SB-10046920-7337SI M17 08 12
Cooling SystemsAugust 2012
Technical Service

SUBJECT**Service Action: Retrofit of the Engine Coolant Temperature Sensor****MODEL**

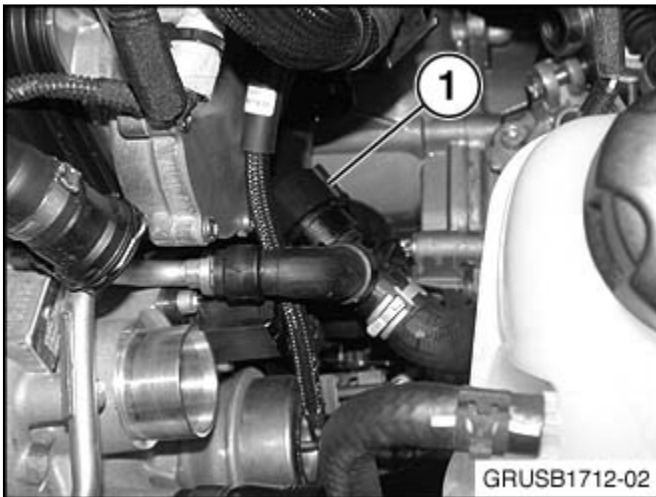
Remove the coolant hose (1). This hose will not be reused.

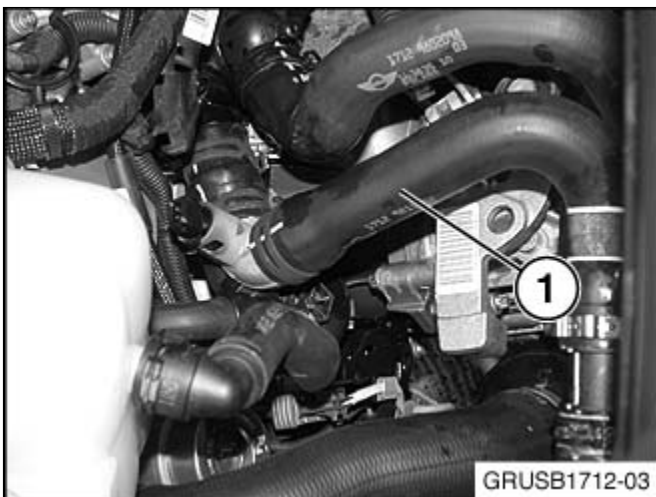
N18 engine only! Install spacer P/N 64 53 7 578 707 (1) on the coolant line as shown.

Note: The spacer needs to stay in this position when installing the new coolant hose P/N 17 12 7 647 009 (next step).

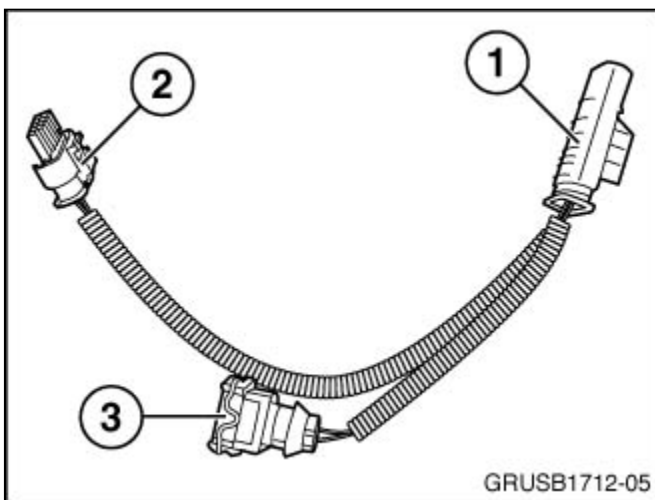
Install the new coolant hose with sensor P/N 17 12 7 647 009 (1).
